400 CONGRESS STREET
UNION MUTUAL INS. CO. # 2

Location - 404-424 Congress St.
Owner - Union Mutual Life Insurance Co.

Job - New 5-story masonry building

THIRD FLOOR

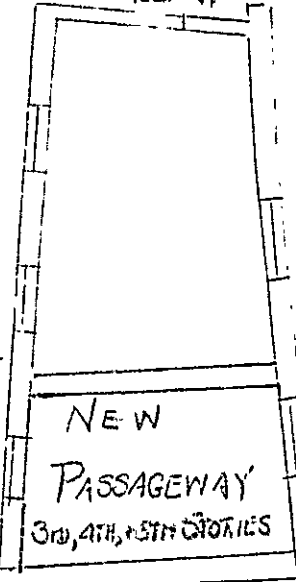
Examination of plan filed with application for permit amendment involving construction of a three story passageway between the Congress Street building and the Exchange Street building of the Union Mutual Life Insurance Company discloses variances from Building Code requirements as listed below. Before the amendment can be issued it is necessary that a revised plan indicating compliance be filed for checking and approval. Details in question are as follows:-

1. Because of the different types of construction of the existing buildings and the total area involved, single Class A labelled fire doors are required on openings to passageway in third and fourth stories.
2. If and when new opening is cut in wall between receiving room and Exchange Street building similar fire doors will be required on both openings in first story.
3. A statement of design covering structural steel and reinforced concrete needs to be affixed to revised plan.
